Access Compliance Report Public Rights-of-Way (Curb Ramps)

Main Street: CAMERONS_WAY Cross Street: SMOKE_TREE_DR Location: S

ADA ID: RPAT211102154145 Ramp Type: Type 4 - Parallel Initial Pass/Fail: Fail Overall Compliance: No Severity Score: 32

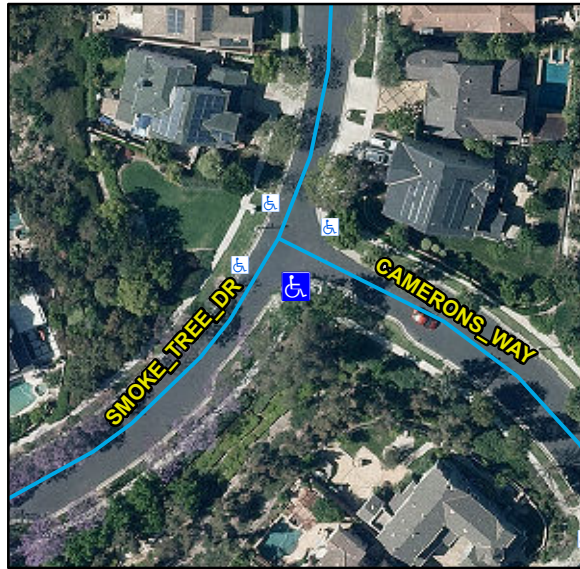
Compliance	Description	Data	Compliance	Description	Data
N/A	Ramp Length LT (in)	99	N/A	Ramp Length RT (in)	93
Yes	Ramp Width LT (in)	52	Yes	Ramp Width RT (in)	51
No	Ramp Run Slope LT (%)	12.7	Yes	Ramp Run Slope RT (%)	0.9
No	Ramp Cross Slope LT (%)	2.2	Yes	Ramp Cross Slope RT (%)	1.9
N/A	Landing Present	N/A	N/A	DWS Provided	N/A
N/A	Landing Length (in)	N/A	N/A	DWS Contrast	N/A
N/A	Landing Width (in)	N/A	N/A	DWS Length (in)	N/A
N/A	Landing Run Slope (%)	N/A	N/A	DWS Full Width	N/A
N/A	Landing Cross Slope (%)	N/A		DWS Offset Type	N/A
N/A	Landing Movement Obstructed?	N/A	N/A	DWS Offset Left (in)	N/A
	Landing Movement Type	N/A	N/A	DWS Offset Right (in)	N/A
N/A	Landing Shared	N/A			
N/A	Clear Space	Yes			
N/A	Clear Space To Crosswalk (in)	N/A			
N/A	Marked Crosswalk 1	No	N/A	Marked Crosswalk 2	No
	Crossing 1 Direction	NE		Crossing 2 Direction	NW
	Marked Crosswalk 1 Width (in)	N/A		Marked Crosswalk 2 Width (in)	N/A

Remove & Replace Curb Ramp With Two New Directional Ramps or Equivalent.
